Access Compliance Report

Public Rights-of-Way

Intersection ID: 11727	Main Street: W_8TH_ST	Cross Street: N_POPLAR_ST	Location: W
ADA ID: 5216547465DF	Ramp Type: PerpDiag	Initial Pass/Fail: Fail	Overall Compliance: No
		Severity Score: 12.5

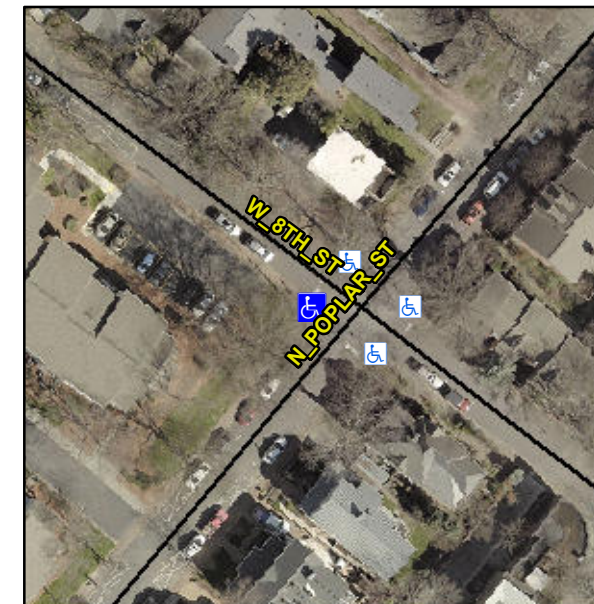
Not Found, R304.2.2

Compliance	Description	Data	Compliance	Description	Data
N/A	Ramp Length (in)	44.0	No	Ramp Slope (%)	11.9
Yes	Ramp Width (in)	72.0	Yes	Ramp XSlope (%)	1.4
N/A	Flare Type LT	N/A	N/A	Flare Type RT	N/A
N/A	Flare Slope LT (%)	N/A	N/A	Flare Slope RT (%)	N/A
N/A	Flare Traversable LT?	N/A	N/A	Flare Traversable RT?	N/A
N/A	Landing Length (in)	N/A	N/A	DWS Provided?	N/A
N/A	Landing Width (in)	N/A	N/A	DWS Contrast?	N/A
N/A	Landing Slope (%)	N/A	N/A	DWS Length (in)	N/A
N/A	Landing X Slope (%)	N/A	N/A	DWS Full Width?	N/A
N/A	Landing Curb? (Y/N)	N/A	N/A	DWS Offset (in)	N/A
N/A	Shared Landing?	N/A			
N/A	Gutter Ponding?	N/A	N/A	Gutter Slope (%)	N/A
N/A	Gutter Lip Ht (in)	N/A	N/A	Gutter X Slope (%)	N/A
N/A	Painted X Walk1?	No	N/A	Painted X Walk2?	No
	X Walk 1 Direction	To SE		X Walk 2 Direction	To NE
N/A	X Walk 1 Width (in)	N/A	N/A	X Walk 2 Width (in)	N/A
	X Walk 1 Slope (%)	7.5		X Walk 2 Slope (%)	5.8
	X Walk 1 X Slope (%)	1.1		X Walk 2 X Slope (%)	2.4

Remove & Replace Curb Ramp With Two New Directional Ramps or Equivalent.
